### **Agenda Item 3**

#### **437 N. Green Bay Road Variances from Front and Corner Side Yard Setback Regulations**

## STAFF REPORT AND RECOMMENDATION

**Agenda Item 4**

**SITE PLAN** N  
1' = 20'-0"  
**POWERS RESIDENCE**  
437 N, GREEN BAY RD.  
LAKE FOREST, IL. 60045

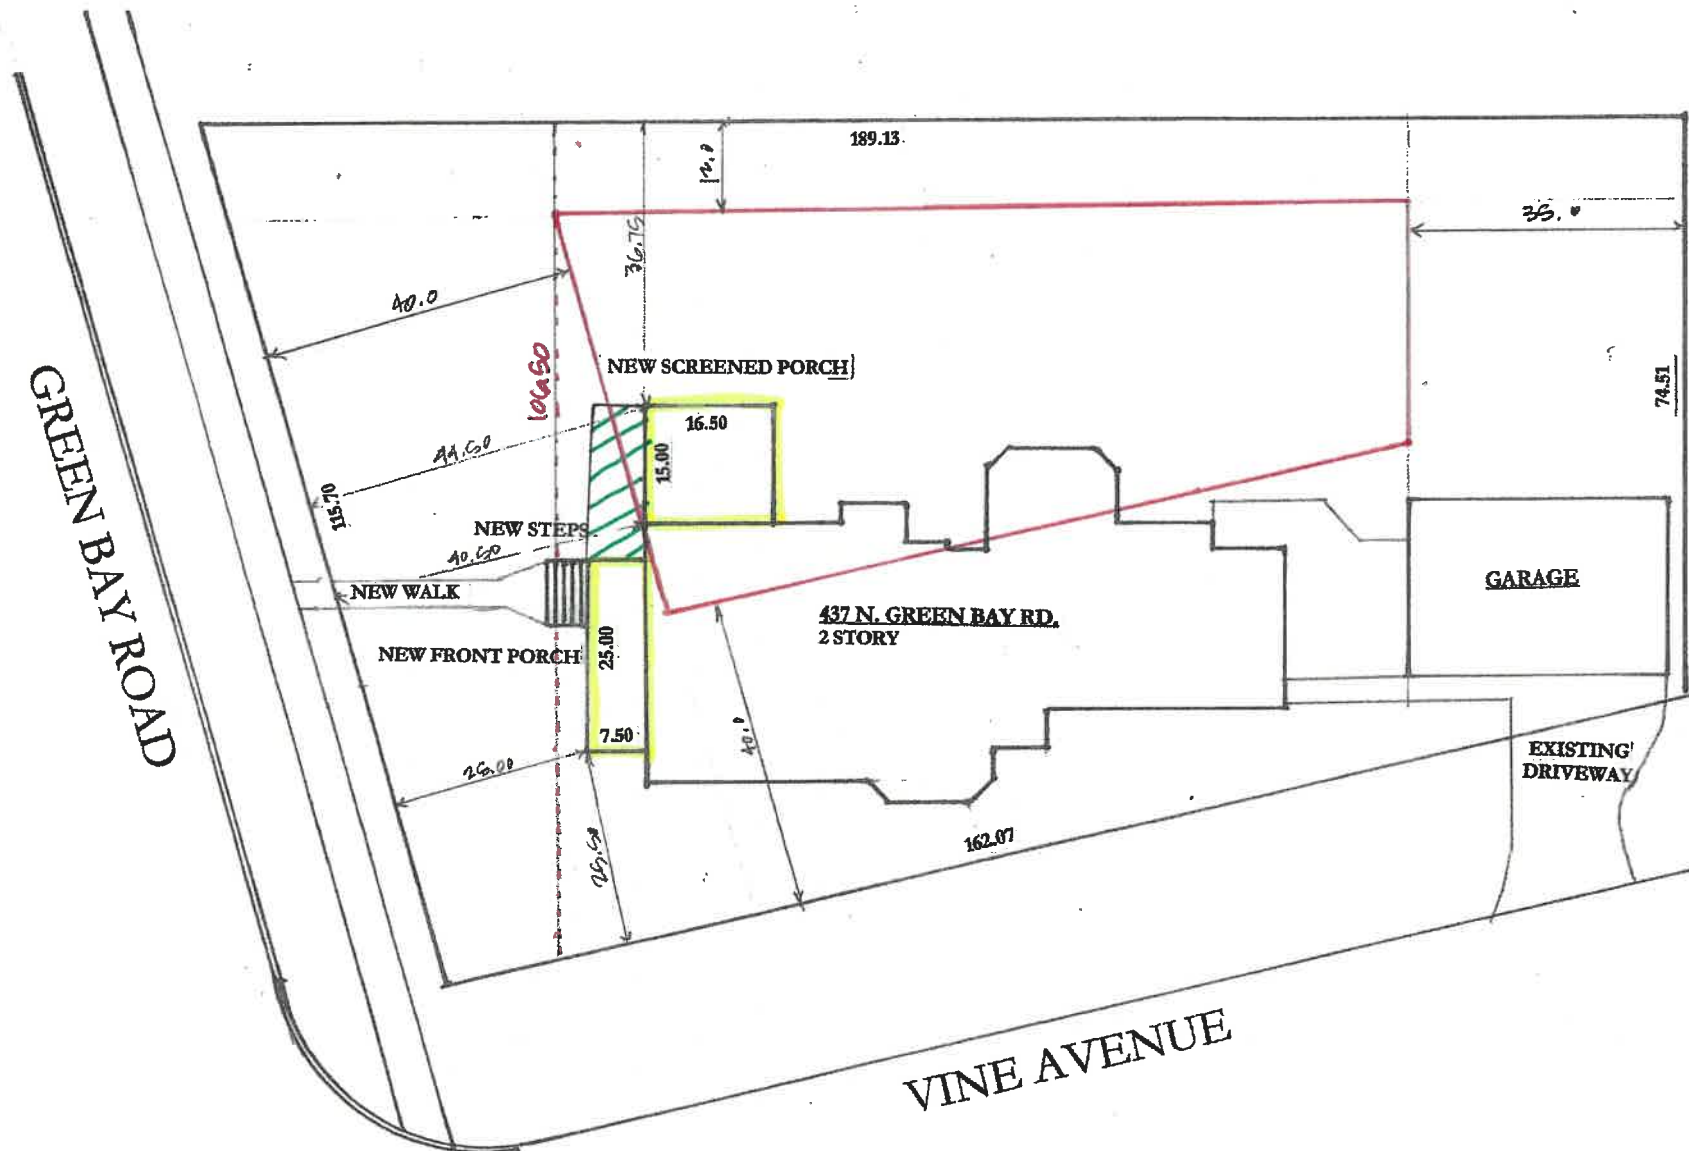
The existing open front porch, proposed for demolition, will be replaced with a slightly longer and deeper open front porch. As proposed, the new front porch will encroach about four feet further into the front yard setback, and seven feet further into the corner side yard setback than the existing porch. The existing porch encroaches 11' into the front yard setback (west) and 6' into the corner side yard setback (south).

The existing screen porch, proposed for demolition, relocation and reconstruction, encroaches into the front yard setback. As proposed, the new screen porch will be setback and will comply with the front yard setback. No variances are required for the new screen porch.

Based on the findings presented above, recommend approval of variances to allow construction of a replacement and enlarged open front porch to encroach into the 40' front yard setback by no more than 14 feet at the point of furthest encroachment and to encroach into the corner side yard setback no more than 15 feet at the point of furthest encroachment as reflected on the plans presented to the Board. The recommendation includes the following condition of approval.

- The front porch shall remain open.

WEST ELEVATION - (ALTERNATE OPTION)  
8' 0"

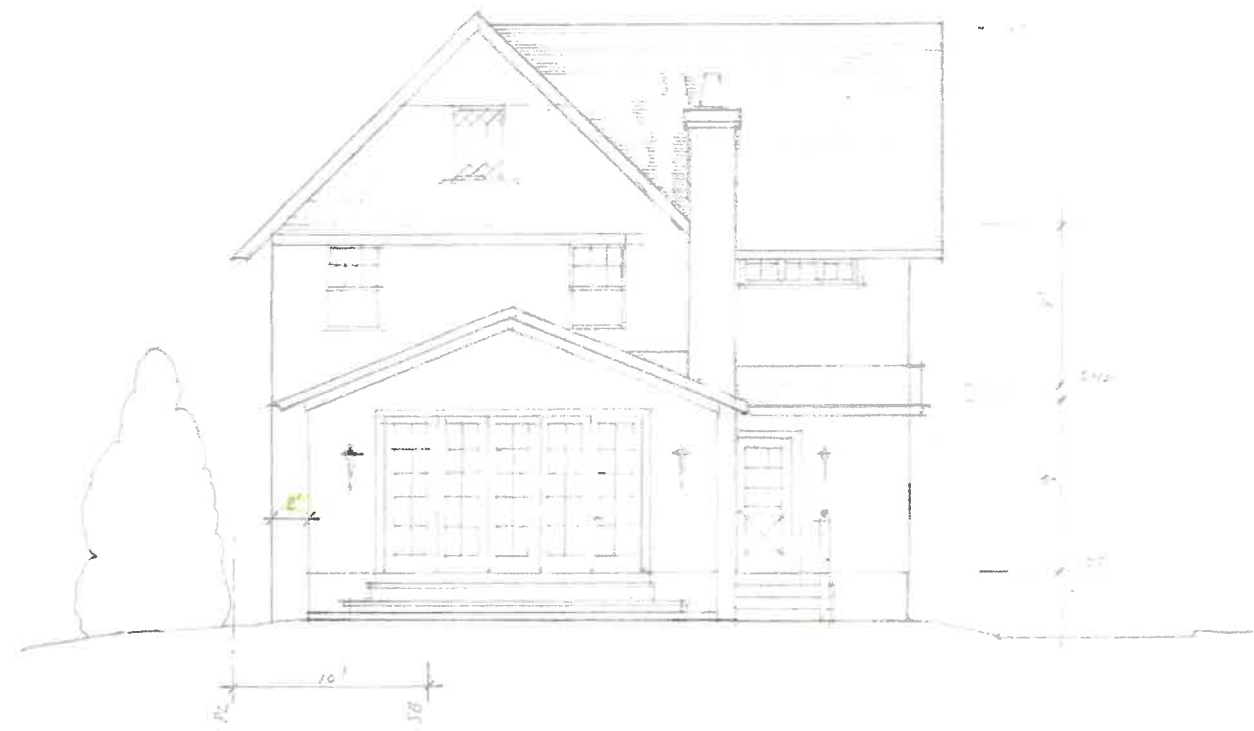
The petitioner provided an alternate footprint and elevations for the rear addition which closely aligns with the 6'9" encroachment of the existing single story rear element instead of pushing out toward the property line. The alternate appears workable although a variance is still required. While the alternate may require the petitioner to modify the envisioned interior furniture layout, it does not appear to present any significant loss or hardship to the petitioners. A hardship cannot be the result of actions or desires of prior or present property owners. The stepped-in wall is helpful in breaking up the wall massing along the interior side (north) yard and allows minimal space for construction and future maintenance.

**Staff recommends approval of the alternate rear addition plan with an encroachment into the 10' setback not to exceed the encroachment of the existing rear entry element which will be removed and replaced.**
